# HYUNDAI Technical Service Bulletin

Group	FUEL
Number	08-FL-005
Date	MARCH, 2008
Model	2007-2008 ELANTRA

## RATTLE NOISE FROM ACCELERATOR CABLE

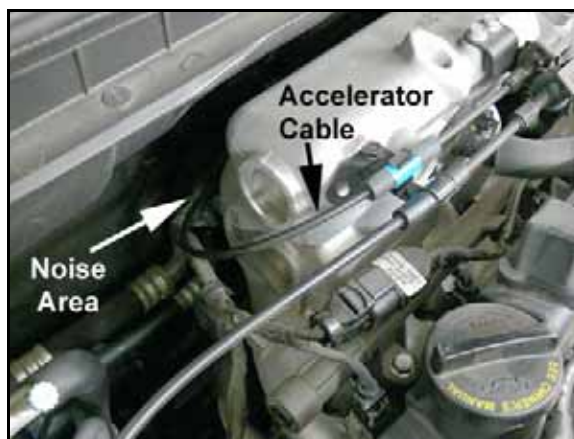
Some Elantra vehicles may have a rattle/buzz/tapping noise from the accelerator cable. This noise is usually described as a body noise heard near the base of the windshield.

1. Locate the unused plastic clip located behind the engine on the bulkhead.

2. Snap the accelerator cable into the clip.
